Florida Power & Light Company
Turkey Point Plant, Units 6 & 7
COL Application

**Turkey Point Units 6 & 7
COL Application
Part 4, Technical Specifications**

PLANT SPECIFIC TECHNICAL SPECIFICATIONS (PSTS)

Section A. PSTS and Bases Differences from the DCD GTS and Bases (PTN COL 16.1-1)

FIGURE 4.1-1 Low Population Zone and Site Boundary Map

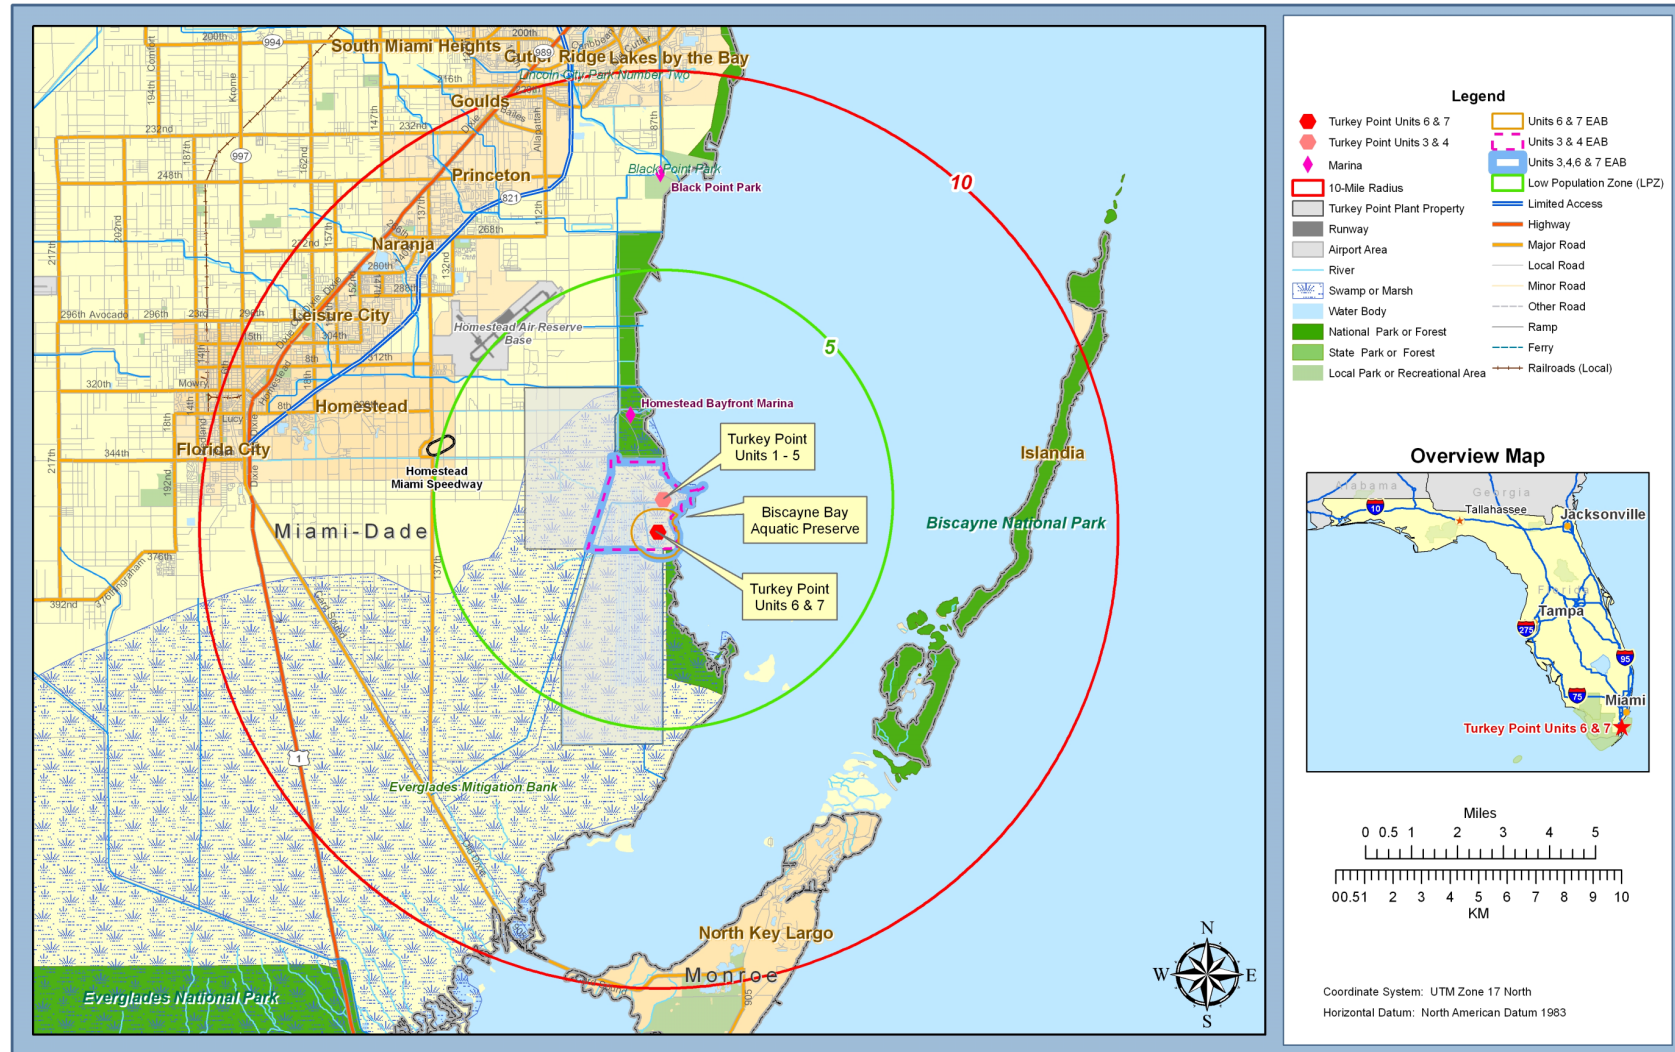
GTS 4.1.1 The bracketed information in the GTS reads:
[This information will be provided by the combined license applicant.]

Replace the bracketed information in the GTS with the following:
The LPZ is defined by the 5 mile radius from the site center point as shown in Figure 4.1-1.

Replace the bracketed information in the GTS with the following:
The Site Boundary is shown in Figure 4.1-1. The Exclusion Area Boundary is shown in Figure 4.1-2.

Justification:
Bracketed information is replaced to establish Site Boundary and Exclusion Area Boundary for PTN consistent with the descriptions identified in FSAR Sections 2.1.1.2 and 2.1.2
